# Access Compliance Report

## Public Rights-of-Way

### (Curb Ramps)

Intersection ID: 21061	Main Street: SARDIS_RD	Cross Street: SMITHFIELD_DR	Location: SW
ADA ID: D2CB0C13829A	Ramp Type: PerpDiag	Initial Pass/Fail: Fail	Overall Compliance: No
Severity Score: 25			
Codes/Mitigation Info/Possible Solution		Field Measurements/Component Compliance

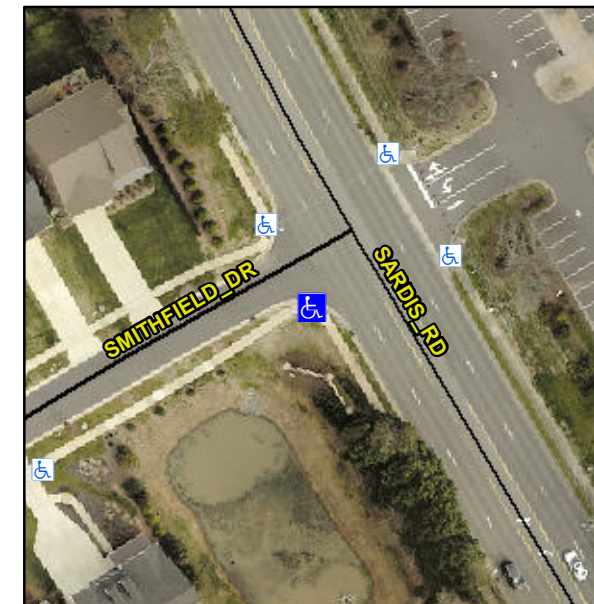
**Not Found, R304.2.2, R304.5.3**

Compliance	Description	Data	Compliance	Description	Data
N/A	Ramp Length (in)	60.0	No	Ramp Slope (%)	8.7
Yes	Ramp Width (in)	60.0	No	Ramp XSlope (%)	6.5
N/A	Flare Type LT	N/A	N/A	Flare Type RT	N/A
N/A	Flare Slope LT (%)	N/A	N/A	Flare Slope RT (%)	N/A
N/A	Flare Traversable LT?	N/A	N/A	Flare Traversable RT?	N/A
N/A	Landing Length (in)	N/A	N/A	DWS Provided?	N/A
N/A	Landing Width (in)	N/A	N/A	DWS Contrast?	N/A
N/A	Landing Slope (%)	N/A	N/A	DWS Length (in)	N/A
N/A	Landing X Slope (%)	N/A	N/A	DWS Full Width?	N/A
N/A	Landing Curb? (Y/N)	N/A	N/A	DWS Offset (in)	N/A
N/A	Shared Landing?	N/A			
N/A	Gutter Ponding?	N/A	N/A	Gutter Slope (%)	N/A
N/A	Gutter Lip Ht (in)	N/A	N/A	Gutter X Slope (%)	N/A
N/A	Painted X Walk1?	No	N/A	Painted X Walk2?	No
	X Walk 1 Direction	To E		X Walk 2 Direction	To N
N/A	X Walk 1 Width (in)	N/A	N/A	X Walk 2 Width (in)	N/A
	X Walk 1 Slope (%)	0.8		X Walk 2 Slope (%)	5.9
	X Walk 1 X Slope (%)	5.4		X Walk 2 X Slope (%)	3.0

**Remove & Replace Curb Ramp With Two New Directional Ramps or Equivalent.**
